# Access Compliance Report

## Public Rights-of-Way

### (Curb Ramps)

Intersection ID: 16168	Main Street: CORONADO_DR	Cross Street: FARMINGDALE_DR	Location:	N
ADA ID: C724870CC067	Ramp Type: PerpDiag	Initial Pass/Fail: Fail	Overall Compliance: No	Severity Score: 10

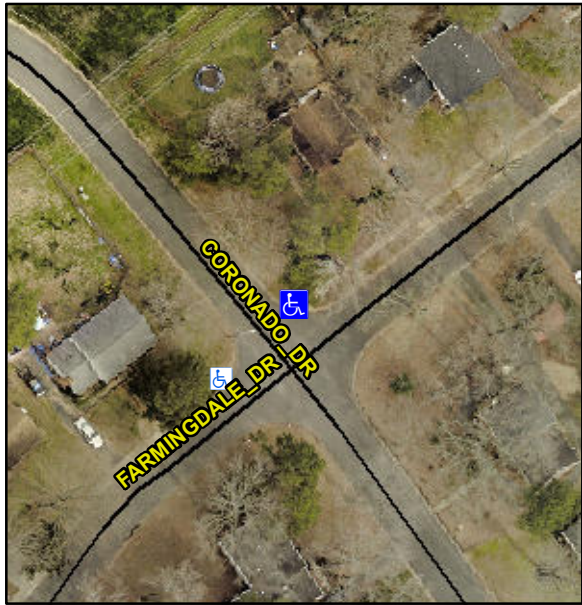
Codes/Mitigation Info/Possible Solution			Field Measurements/Component Compliance					
	Possible Solutions:		Compliance	Description	Data	Compliance	Description	Data
	<b>Remove &amp; Replace Curb Ramp With Two New Directional Ramps or Equivalent.</b>		N/A	Ramp Length (in)	48.0	Yes	Ramp Slope (%)	5.7
			No	Ramp Width (in)	47.0	No	Ramp XSlope (%)	3.7
			N/A	Flare Type LT	N/A	N/A	Flare Type RT	N/A
			N/A	Flare Slope LT (%)	N/A	N/A	Flare Slope RT (%)	N/A
			N/A	Flare Traversable LT?	N/A	N/A	Flare Traversable RT?	N/A
			N/A	Landing Length (in)	N/A	N/A	DWS Provided?	N/A
			N/A	Landing Width (in)	N/A	N/A	DWS Contrast?	N/A
			N/A	Landing Slope (%)	N/A	N/A	DWS Length (in)	N/A
			N/A	Landing X Slope (%)	N/A	N/A	DWS Full Width?	N/A
Surveyor Notes:	N/A		N/A	Landing Curb? (Y/N)	N/A	N/A	DWS Offset (in)	N/A
			N/A	Shared Landing?	N/A			
			N/A	Gutter Ponding?	N/A	N/A	Gutter Slope (%)	N/A
			N/A	Gutter Lip Ht (in)	N/A	N/A	Gutter X Slope (%)	N/A

N/A	Painted X Walk1?	No	N/A	Painted X Walk2?	No
				X Walk 1 Direction	To SW		X Walk 2 Direction	To SE
			N/A	X Walk 1 Width (in)	N/A	N/A	X Walk 2 Width (in)	N/A
				X Walk 1 Slope (%)	1.6		X Walk 2 Slope (%)	4.3
				X Walk 1 X Slope (%)	3.4		X Walk 2 X Slope (%)	1.2
			N/A	Ramp inside XWalk1?	N/A	N/A	Ramp inside XWalk2?	N/A
PROW/ADA:	<b>Not Found, R304.5.1, R304.5.3</b>			Road Slope (%)	1.4	N/A	Clear Space?	N/A
				Road X Slope (%)	4.8	N/A	Clear Space to XWalk (in)	N/A
			N/A	Any Obstructions?	N/A	N/A	Storm Grate/Utility Hazard?	N/A
				Obstruction Type			Storm Grate/Utility Type	
					N/A			N/A
						Yes	Surface Condition? (G/P)	Good
Total Cost:		\$ 3200.00
